Clarksburg Ten Mile Creek Sewer Study

Clarksburg/Ten-Mile Creek Citizens Advisory
Committee

September 24, 2015

Summary of Questions and Comments from CAC Members

Map 10: Properties East of I-270

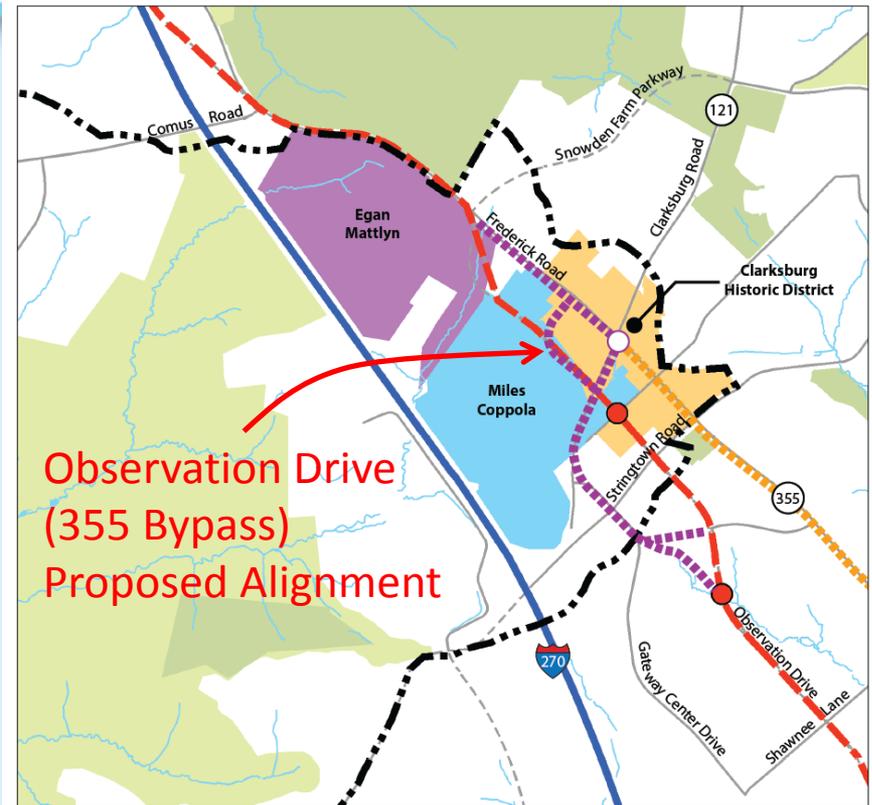
The plan to align sewers along the future Observation Drive west of Clarksburg Road – found in Alternatives 6, 7, 8, and 9 -- seems unrealistic (*Due to factors such as - Schedule, Final Alignment, Environmental Impact Analysis and State Funding etc.*). We ask that WSSC present to the CAC alternatives that can substitute for the bypass alignment if the road is not in design phase or built by the time property owners wish to develop.

- Please see the proposed alignment of Observation Drive (MD 355 Bypass) from the Approved and Adopted Ten Mile Creek area Limited Amendment – July 2014
- Sewer service to Mile Coppola property could potentially follow any access road built to connect the development Clarksburg road.

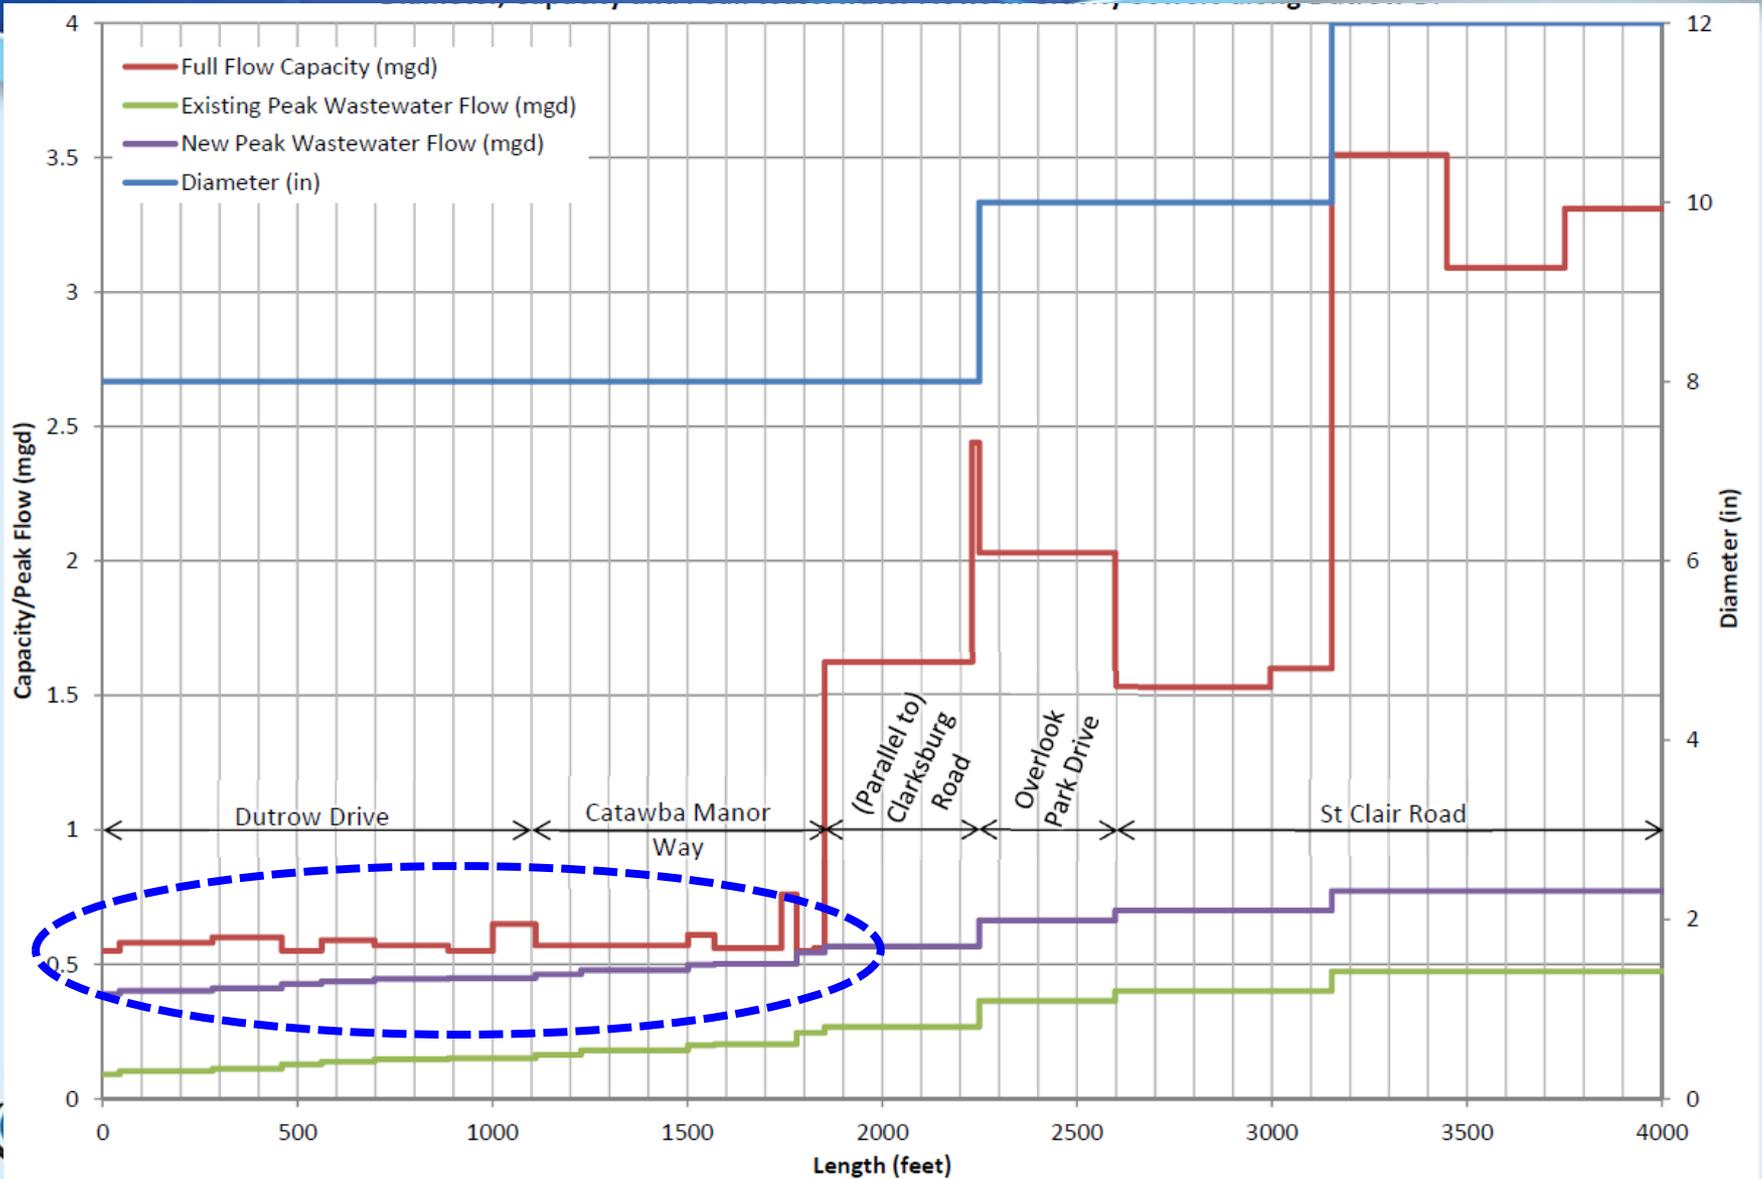
Another question that should be addressed more thoroughly is the “orphaned properties” in both Alternatives 8 and 9.

- The parcels north of the Frederick Road could utilize grinder pumps to convey the wastewater to gravity sewers on Dutrow drive or to the gravity sewers on Frederick road. A few things to consider:
 - May need separate pressure lines for residential and non-residential development (CRT Zoning)
 - Capacity of Dutrow Drive sewers.
- It is also possible parcels south of the Frederick road can use grinder pumps to convey wastewater to the gravity sewers on Frederick Road.
- WSSC does not determine a property's potential for development. This study is aimed at developing a plan to provide sewer service to properties eligible to receive sewer service (based on a change in sewer category)

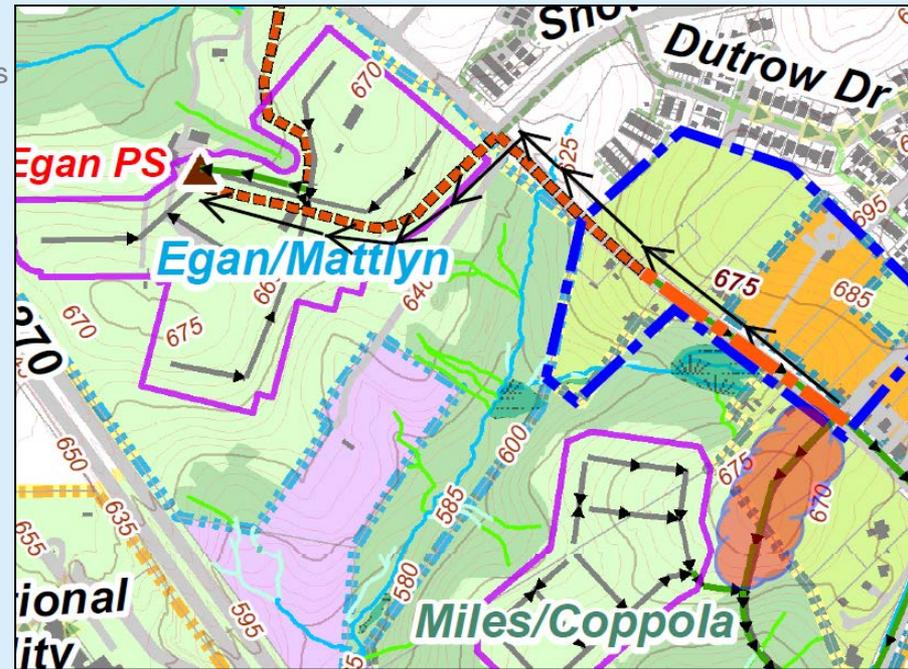
Concerned about the plan to use deep gravity sewers for a length of 1,750 feet (one-third of a mile) along Rt. 355 and Observation Drive. This area is already known to have shallow depth to bedrock. Blasting would certainly be necessary to install these sewers and could have a serious impact on the geology, surface and groundwater, and existing buildings in the area. We would like to know what alternatives are available to using deep gravity sewers.

- More invasive construction methods than open cut would likely be necessary to construct the deep sanitary sewer within bedrock along Rt. 355 and Observation Drive. This may include:

- Controlled Blasting
 - Tunneling through rock
- Both options are technically feasible. Could include a pre- and post-construction geotechnical settlement monitoring program

- WSSC projects have required controlled blasting in the past (Muddy Branch Relief Sewer, Seneca Relief Sewer).
- Blasting is a highly scientific and controlled practice. For narrow trenches, WSSC staff stated that blasting would not likely lead to any widespread damage to homes and structures nearby.

- Alternatives to deep sewer:
 - Alternatives that include Miles North PS do not use a deep Gravity sewer
 - Extend the Egan PS force main further east along Frederick Rd to a shallow sewer discharge point, deleting a portion of the deep sewer along Observation Drive and changing the sewer along Observation Drive to shallow depth.

Capacity of Gravity Sewers on Gateway Center Drive

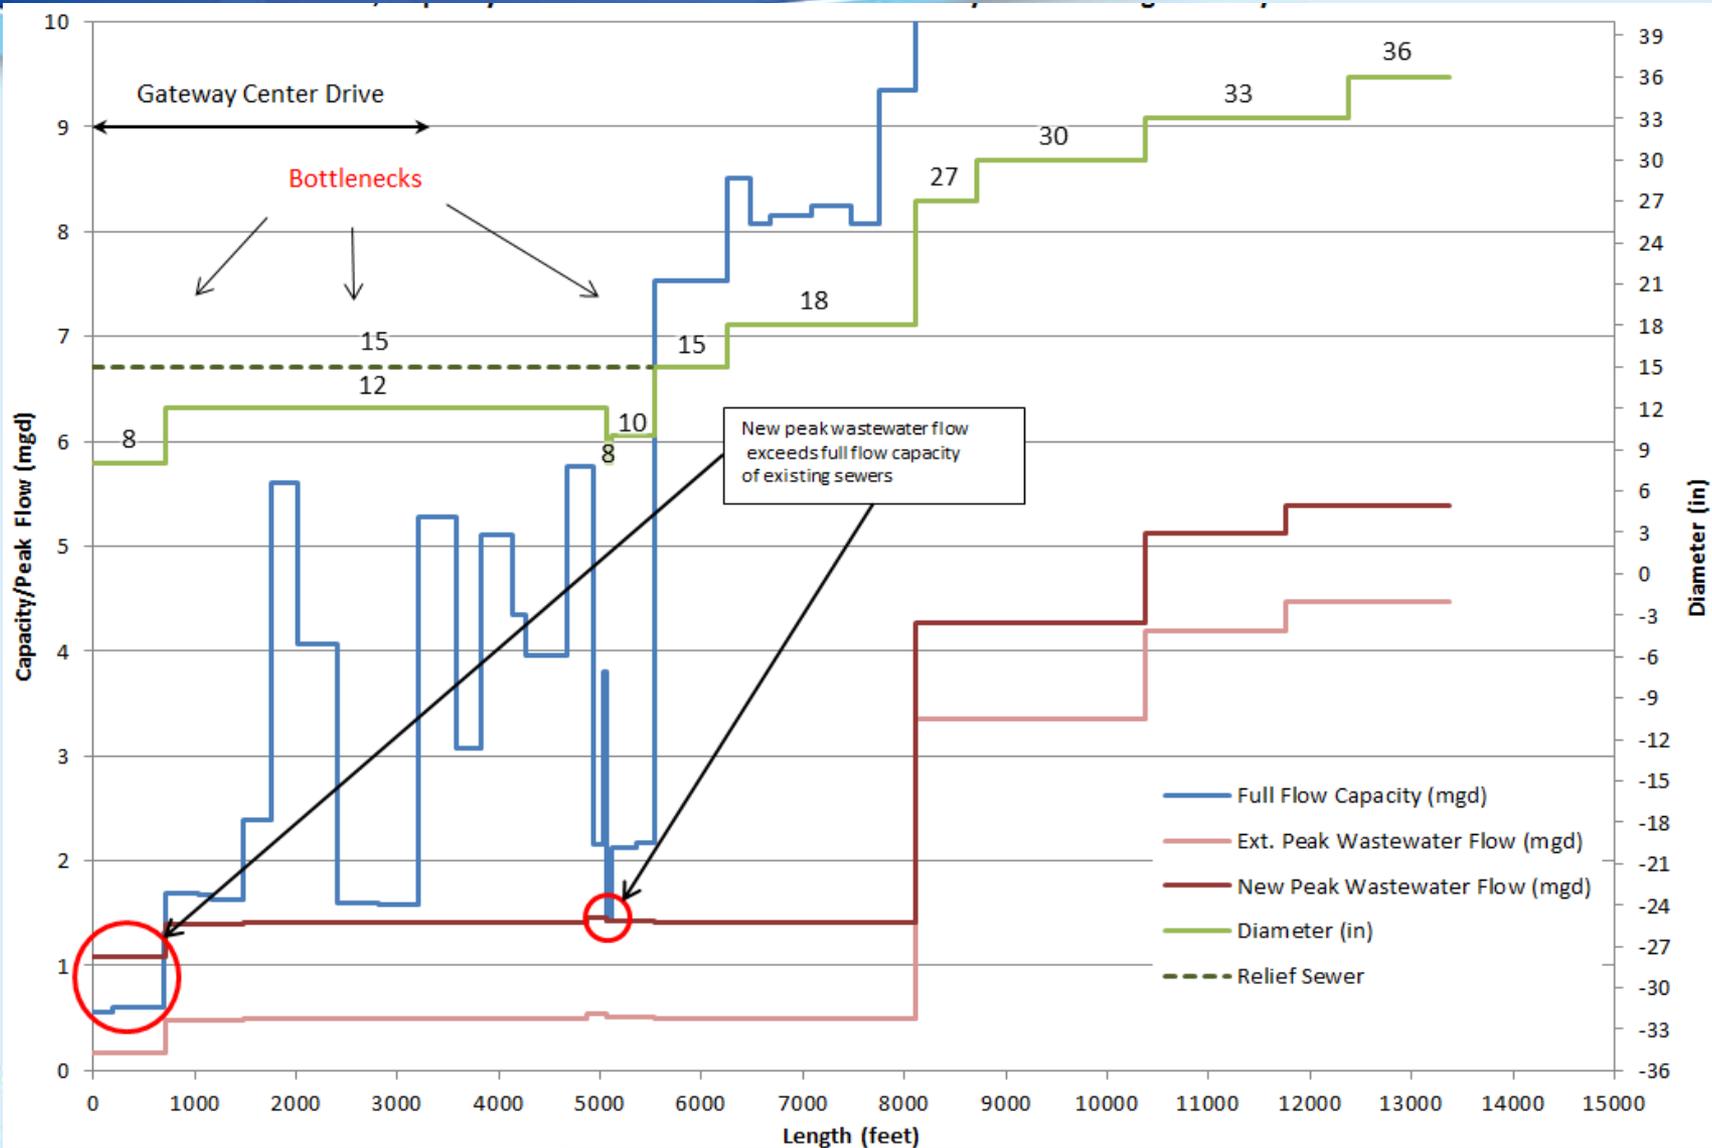
We are also interested in learning more about potential design requirements to mitigate the effects of corrosive gases on force mains. (Interior Coatings, use of PVC/HDPE, redundant/parallel lines). Could these new measures reduce the potential for pipe disintegration, cracking, and leaking and extend the life of the pipes?

- WSSC Force main design guidelines already require an analysis to determine potential for Hydrogen Sulfide generation into proposed or existing sewers (Pomeroy's Equation).
- New design elements currently being considered:
 - Pipe Materials (HDPE, PVC etc)
 - Forcemain redundancy
- These measures are aimed at increasing reliability and extending the life of the pipes.
- New technologies and design guidelines will be adopted by WSSC after a careful and thorough internal analysis.
- New measures are currently being considered by WSSC, but there is currently no date set for their adoption into WSSC's guidelines for force main design.
